Ref: L22321/PAK/21-014

**Re: Noise Amenity Review
Amended Proposal
Animal Keeping Facility (Kennels)
2312 Steve Irwin Way, Landsborough**

Figure 6 Ventilation penetration recommended construction.

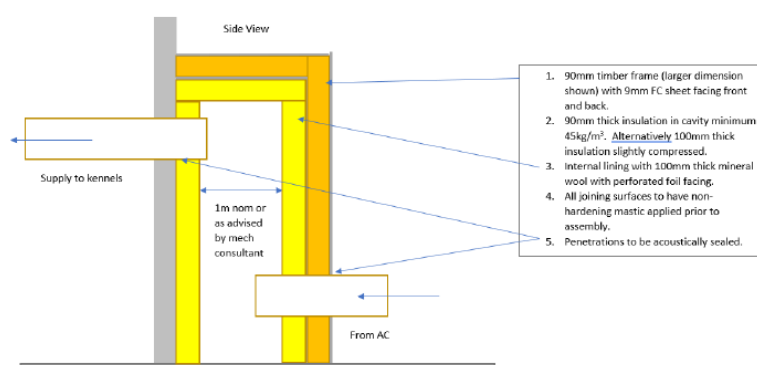
- Acoustically absorptive lining is incorporated into each individual kennel ceiling.
- Attenuation at the point of penetration of AC / ventilation ducting is recommended to utilise a plenum box arrangement as indicated in **Figure 6**.

The detail provided as Figure 6 of the RoadPro and the details in Section 5.1 (Extract above) are considered to provide suitable detail on the acoustic containment to be achieved by a mechanical ventilation (air distribution system) for the kennels.

Plate 2: Acoustic Details – Project Drawings

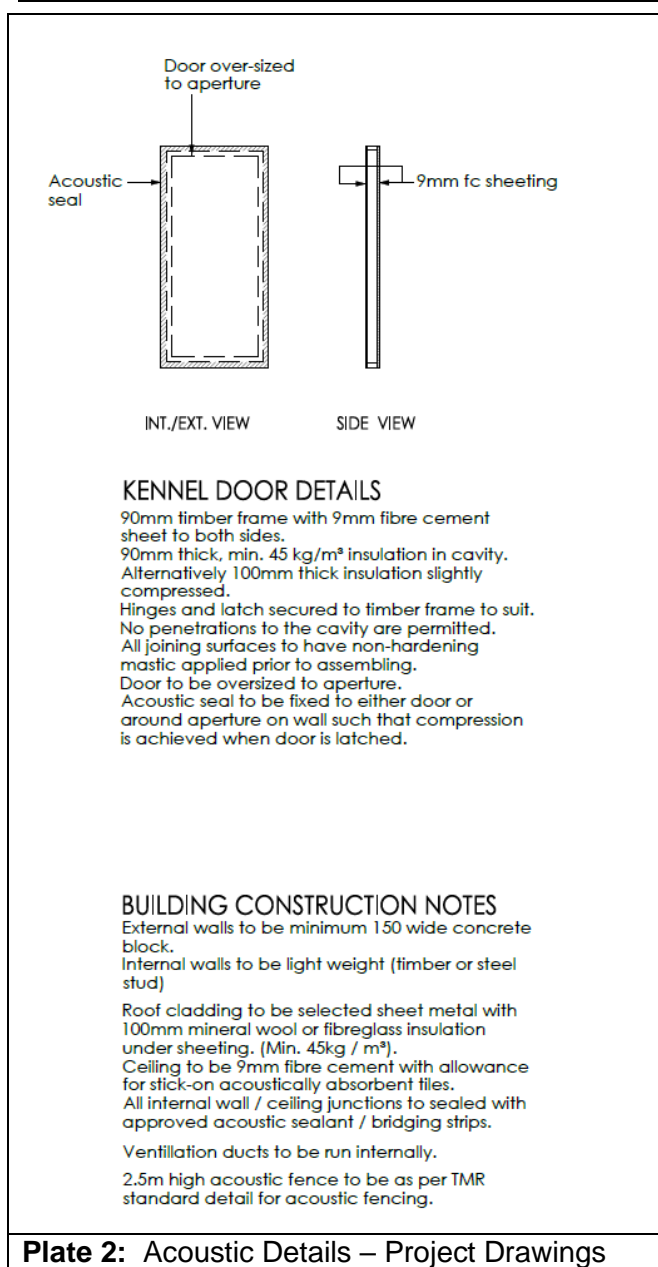
It is my opinion that the above proposed construction details are appropriate in providing acceptable noise containment of dogs enclosed in the kennels during the 6pm to 7am period. Further, the proposed acoustic barriers and acoustic absorptive elements provide containment of daytime noise of dogs outdoors which was not a feature of the original development proposal.

Plate xx: Proposed 1.2 metre high opaque screens between runs (Visual screening) – Project Design Drawings

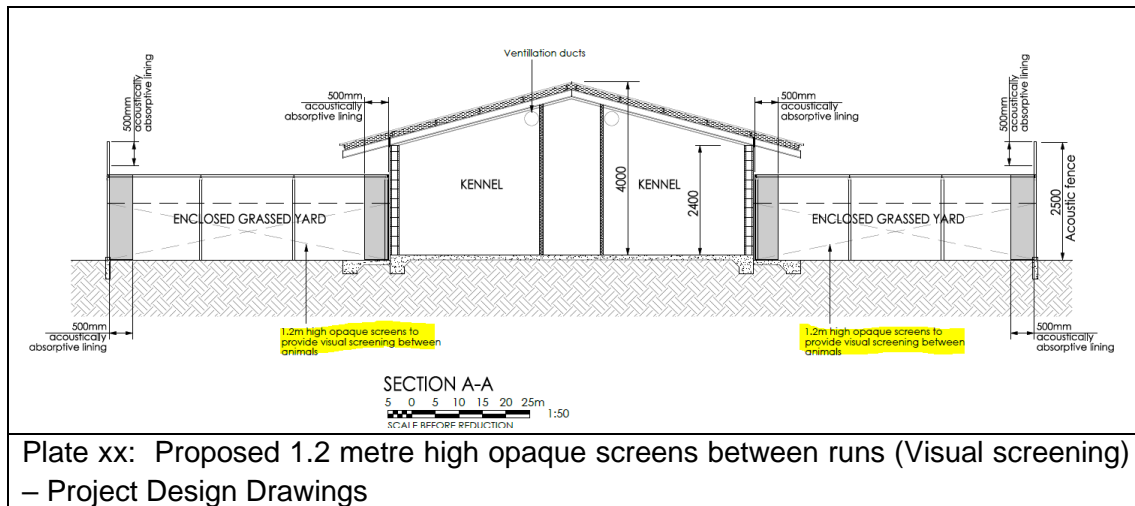
In addition it is noted that the project drawings also identify provision of 1.2 metre high opaque screens to form part of the dividing fences between outdoor runs to provide visual screening between different pens and reduce potential barking. These are considered a necessary inclusion into the design.
